STAGE 3 - SECTION 32

RURAL - CRANFORD BASIN

APPENDIX 2 - CRANFORD BASIN PROPOSED REZONING
WASTEWATER REPORT

SUBJECT Cranford Basin Re-zoning – Wastewater Review

Figure 2: Map showing Site A connection points and details

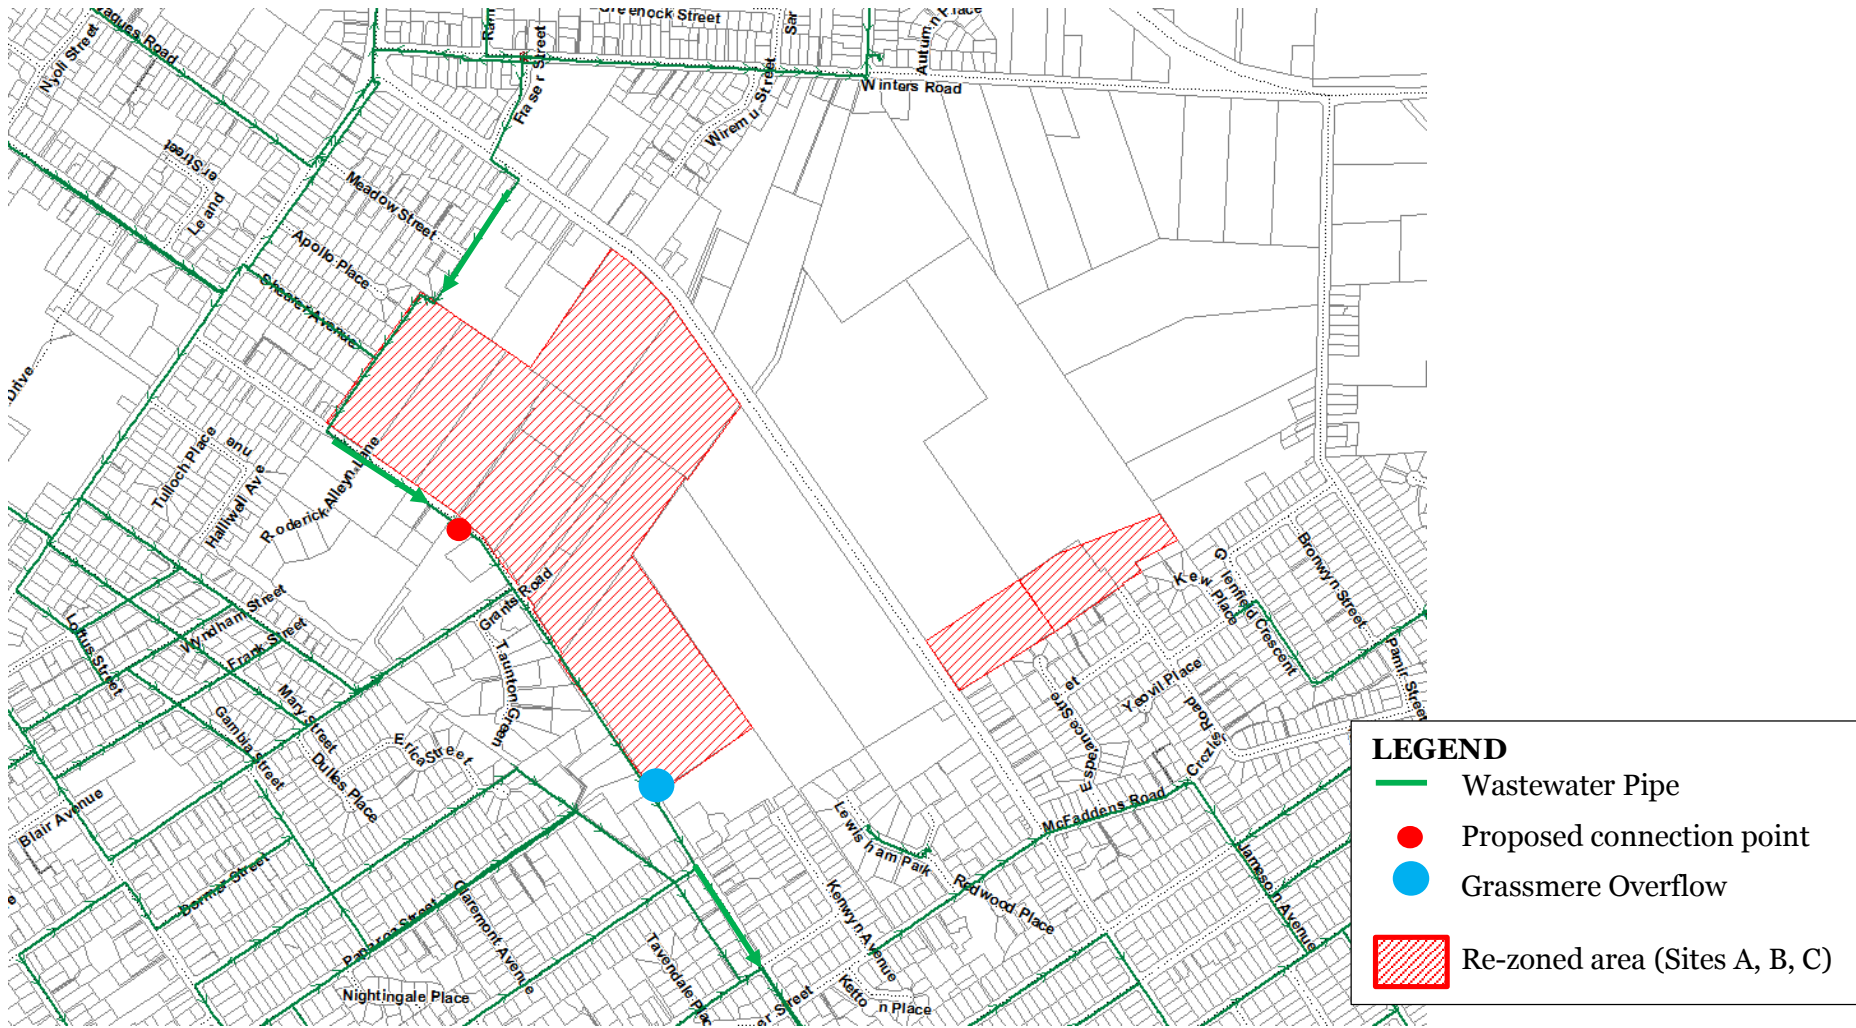
The development at the Grassmere Site covers a large area and is bound by Cranford Street to the east and Grassmere Street to the west. The Northern Relief is aligned down the north and western boundaries of the proposed re-zoning site, and increases in size from a DN750 to DN900 in this section. In order to quantify the effect the re-zoning is likely to have on the wastewater network, the MF from each of the 3 scenarios has been added to the model as a constant flow. The entire flow has been added in at a manhole on Grassmere Street (refer Figure 2).

The Northern Relief is a large trunk main that collects and conveys flow from the north and west of Christchurch to PS1, a terminal pump station which discharges to the Christchurch Wastewater Treatment Plant. Located on the Northern Relief just at the south-west boundary of the Grassmere re-zone site is the Grassmere overflow (PS1/21). The Northern Relief is currently predicted to run surcharged during WWF, with known areas downstream to result in manhole overflows, as well as constructed overflows operating during wet weather events. Previous modelling by CCC/Opus indicated that due to the surcharging in the Northern Relief, the Grassmere overflow was predicted to operate annually, with the Current model therefore predicting it to overflow during the design rainfall event.

The addition of the MF from the re-zoning of Site A exacerbates the current issue in the Northern Relief. While in scenario 1 the increase of 5.8L/s is only an approximate 2% increase in flow in comparison to the 321 L/s PWWF in the Northern Relief at this point, essentially any increase just adds directly to the volume lost at the Grassmere overflow. Table 4 compares the increase in volume lost out of the Grassmere overflow during each of the scenario runs.

- The re-zoning of site A in the Cranford Basin is predicted to exacerbate any current overflow issues at the Grassmere overflow. If the development of this site can be restricted until after proposed upgrades at Grassmere overflow occur, the impact of the addition of these flows to the network will be minimal, with the main impact then being on what volumes to account for during design of the proposed upgrades.

- Consideration should be given to constraining the timing of any potential development to be in line with or following on from the timing of proposed upgrades at the Grassmere overflow. If the development of the re-zoned area occurs prior to the upgrades, the volume lost at the Grassmere overflow during wet weather is predicted to increase.
- Due to the likelihood that there is a high groundwater table at site A, it is recommended that a pressure or vacuum wastewater system be considered rather than gravity.
- A system that is able to attenuate flows during wet weather should be considered. To reduce any increase in overflow volume lost from the network, attenuating WWF from the new developments until after PWWF passes in the network is necessary.

- For the Grassmere site (Site A), consideration should be given to the timing of any potential development to be in line with or following on from the timing of proposed upgrades at the Grassmere overflow. If the development of the re-zoned area occurs prior to the upgrades, the volume lost at the Grassmere overflow during wet weather is predicted to increase.

Figure 3: Map showing Site B & C connection points and details from PS6 catchment

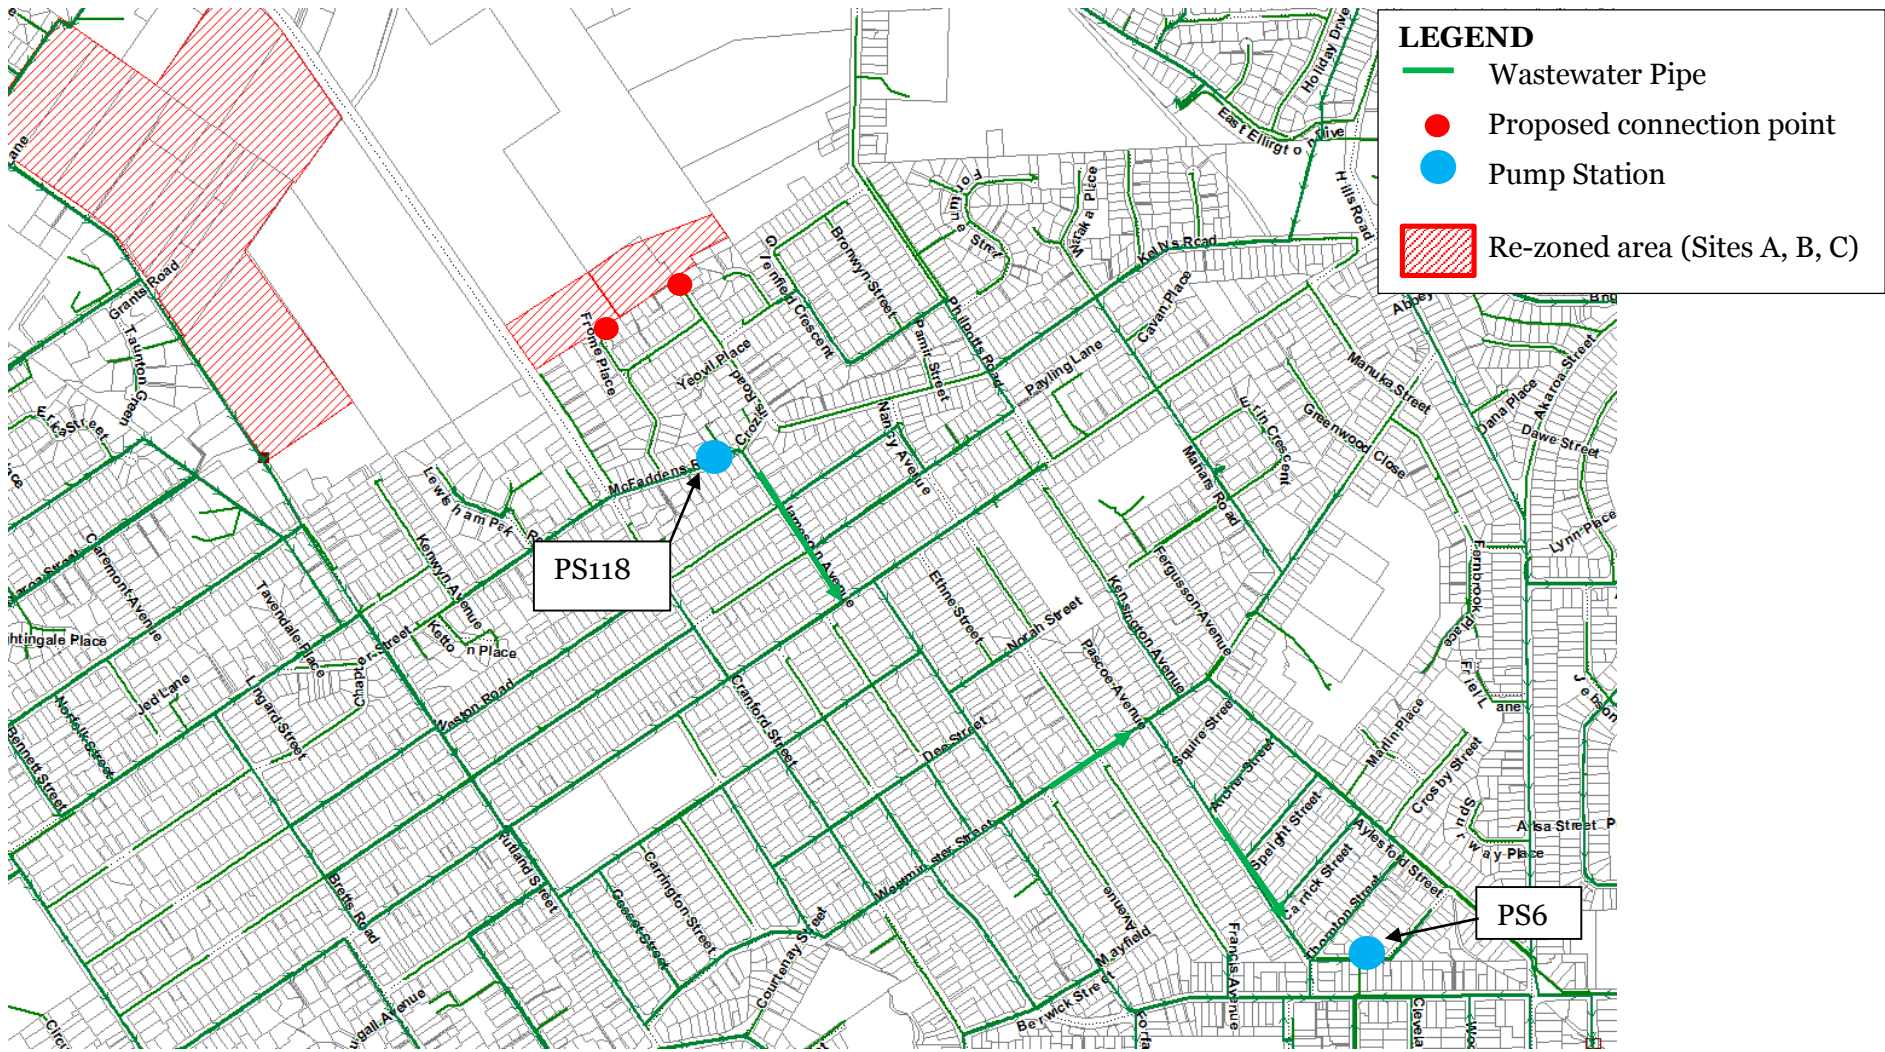
The two developments at Site B and C are able to connect into the DN150 local reticulation on Fromes Place and Croziers Road, refer Figure 3 The DN150 from Fromes Place directs flow to the newly built PS118 (SCIRT) and then discharges to the gravity network feeding PS6. The DN150 on Croziers Road connects into the gravity network feeding PS6.

The flows from the re-zoned area are not predicted to result in any negative impact on the network during dry weather flow (DWF). In wet weather, while the re-zoned area is predicted to only have a reasonably small MF, due to the size of the reticulation it is entering and existing surcharging issues, this small increase is predicted to result in an increased number of manholes with freeboard issues in the network during PWWF. One additional manhole is now predicted to overflow.

It is the pipework in the PS6 catchment (rather than PS6) which is predicted to have capacity issues during DWF. The pipework immediately upstream of PS6 on Harrison Street (WwPipe65 and WwPipe15151 which is the inlet into PS6) are predicted to have the greatest capacity issues due to pipe size and grade. An additional scenario was run to assess if upsizing (from DN375 to DN525) and re-grading this pipework in the model reduces surcharging and overflow issues in the network. Table 5 outlines the results from this scenario run in comparison to both the base model (with no re-zoning of Site B & C) and also with the re-zoned areas included.

The results indicate that upsizing and re-grading WwPipe65 and WwPipe15151 resolve the additional manhole overflow and freeboard issues caused by the addition of flows from the re-zoning. The SCIRT project encompassing the PS6 catchment is still in the detailed design phase at SCIRT. It is recommended that CCC investigate if any upgrades to these pipes are programmed as part of the SCIRT work and if this is not the case then any upgrades to this pipework should be included as a constraint to re-zoning and development

- No development to occur prior to CCC undertaking further assessment to determine if pipe upgrades are required immediately upstream of PS6 (refer results for specific pipes) and allowing for the implementation of these upgrades to take place if required.
- Due to infiltration issues in the current network from a high groundwater table it is recommended that a pressure or vacuum wastewater system be considered rather than gravity.
- A system that is able to attenuate flows during wet weather should be considered. To avoid the risk of manhole overflows (and freeboard issues), attenuating WWF from the new developments until after PWWF passes in the network is necessary.

- For the Case and Crozier sites (Sites B and C), it is recommended that no development occur prior to CCC undertaking further assessment to determine if pipe upgrades are required immediately upstream of PS6 (refer results for specific pipes) and allowing for the implementation of these upgrades to take place if required.
